RE: 7-Eleven 44808 / Speedway 8690 6100 San Mateo Blvd NE Grading and Drainage Plan Engineer's Stamp Date: 2/28/2025 Hydrology File: E18D064 Case # HYDR-2025-00165

PO Box 1293 Based upon the information provided in your submittal received 5/9/2025, the Grading plan is **approved** for Building Permit and Grading Permit. Please attach a copy of this approved plan in the construction sets for Building Permit processing along with a copy of this letter.

GRADING & DRAINAGE PLAN

Sheet Number: **C-1.1**

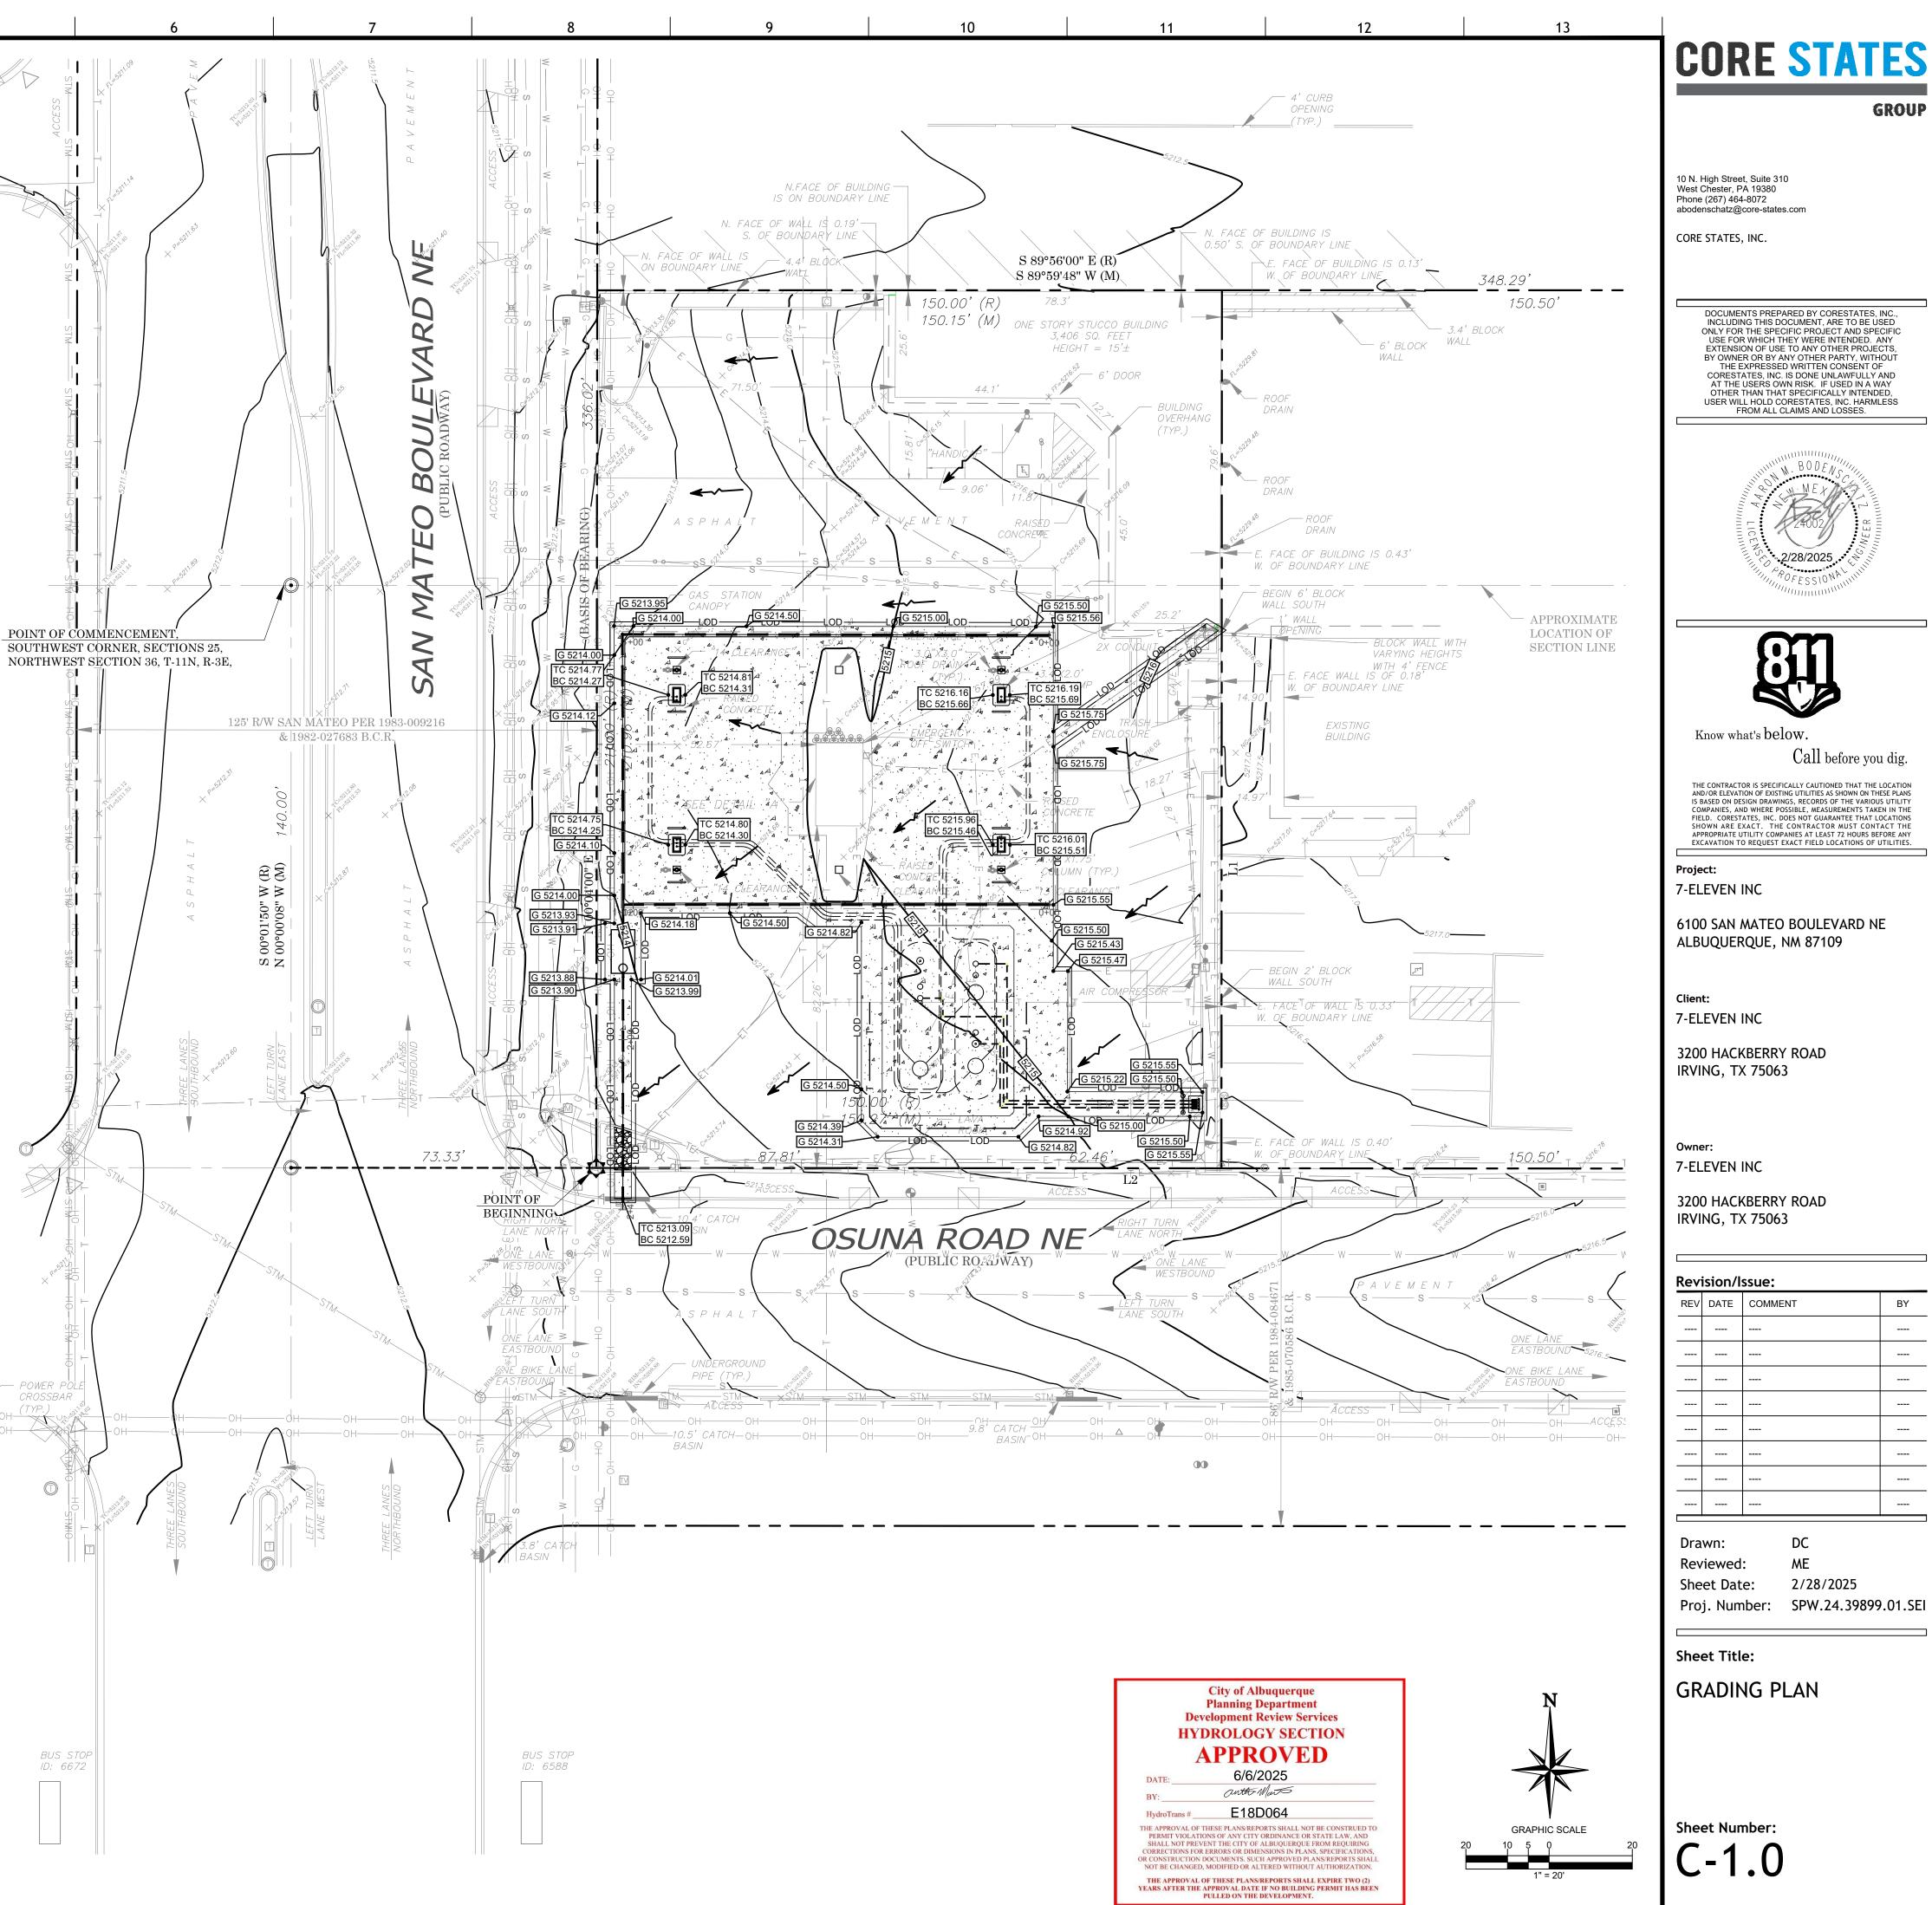
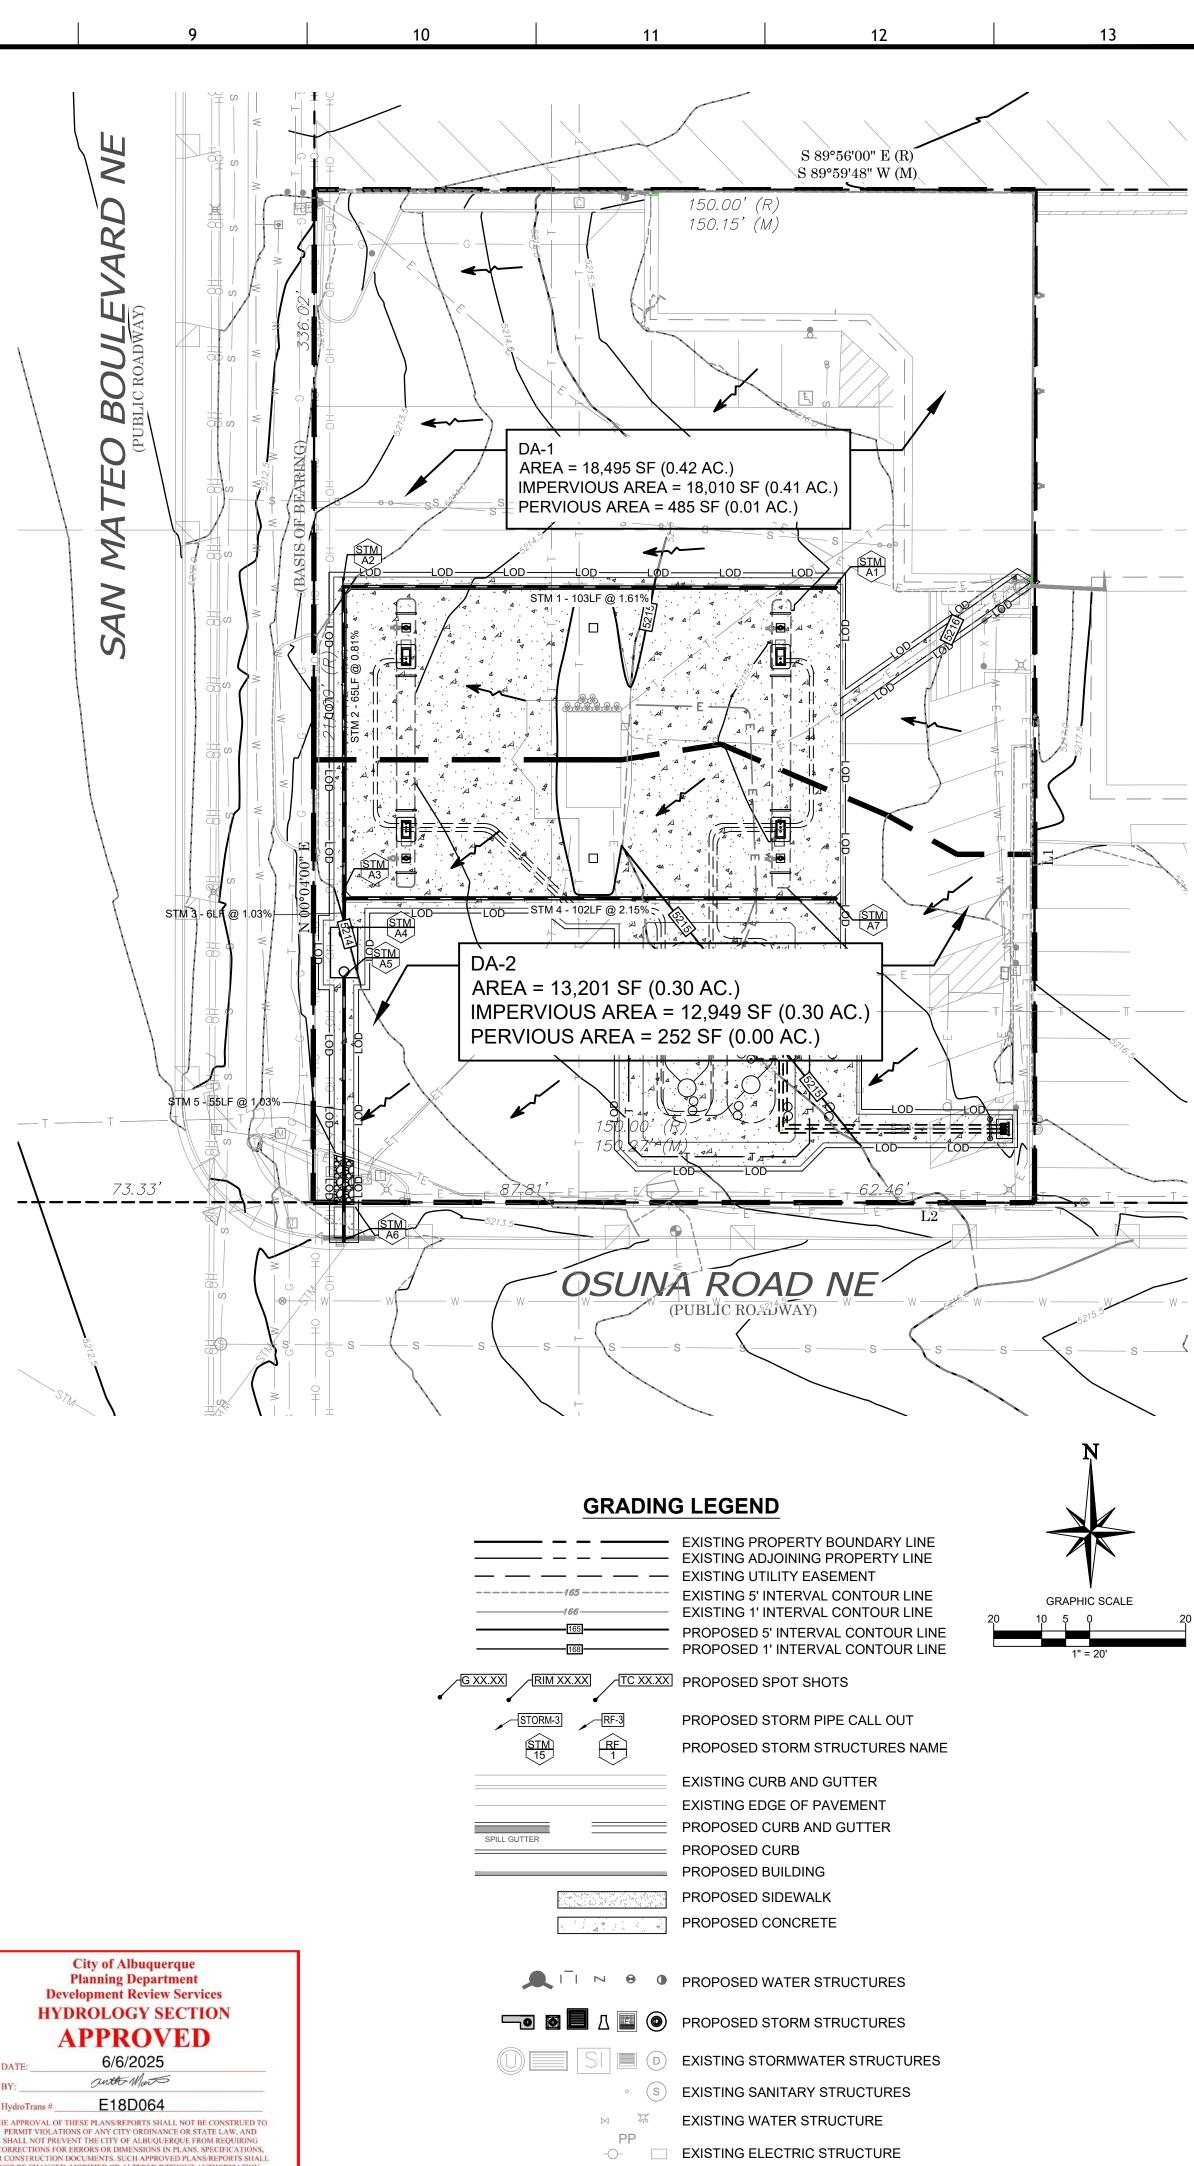
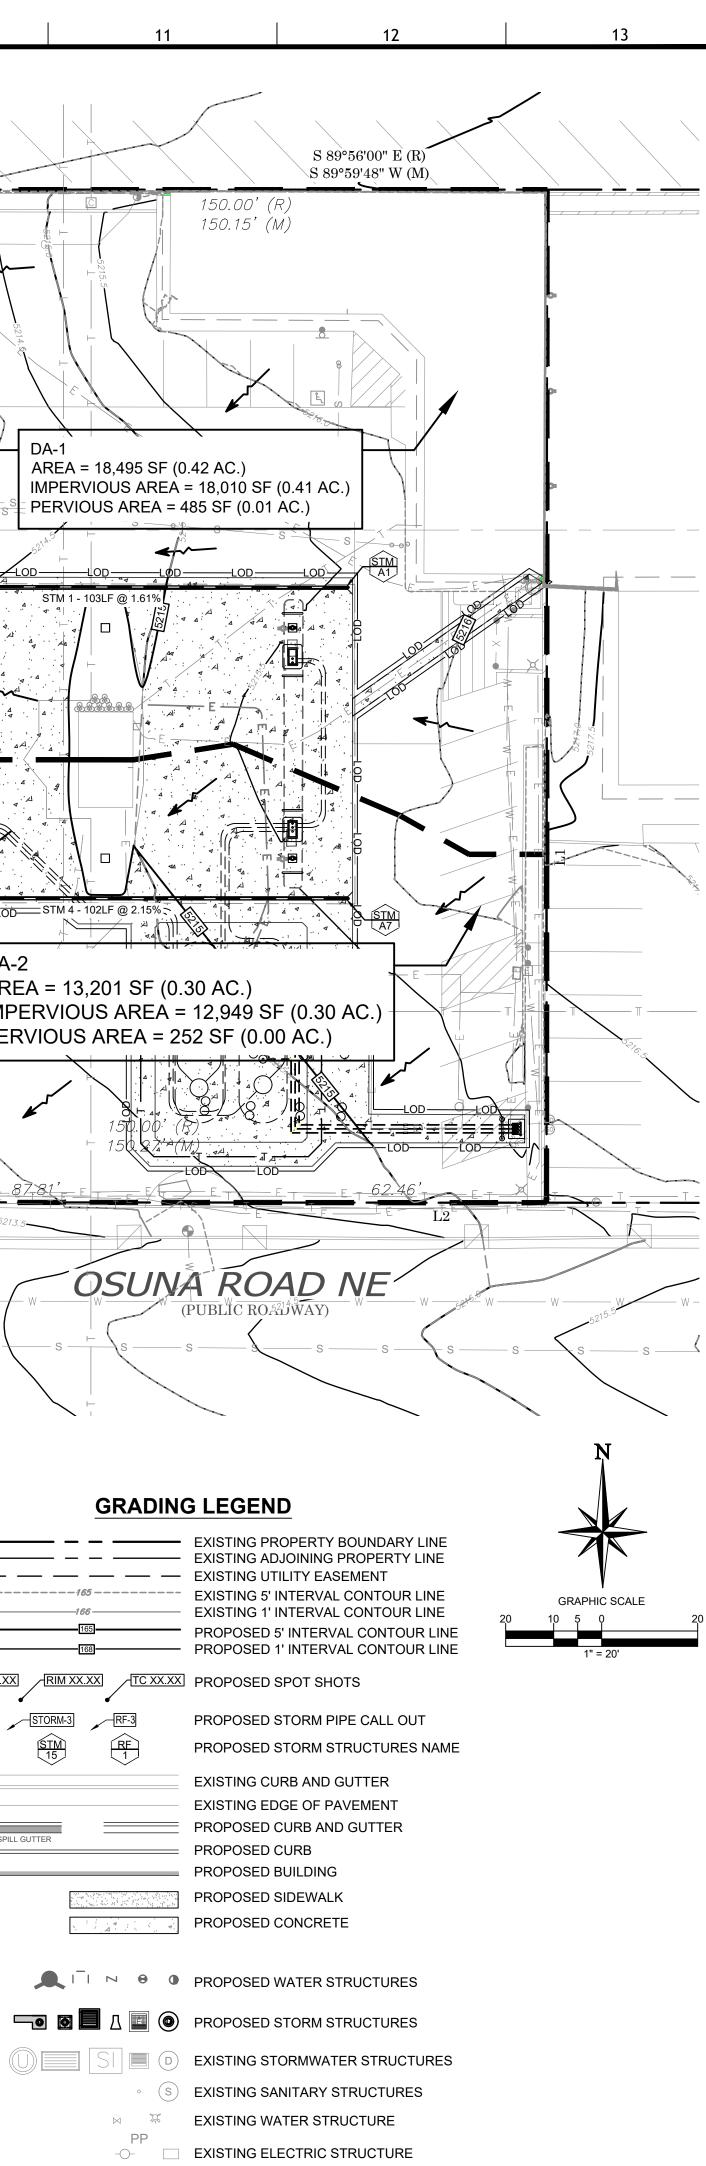
1. Engineer's Certification, per the DPM Part 6-14 (F): *Engineer's Certification Checklist For Non-Subdivision* is required.
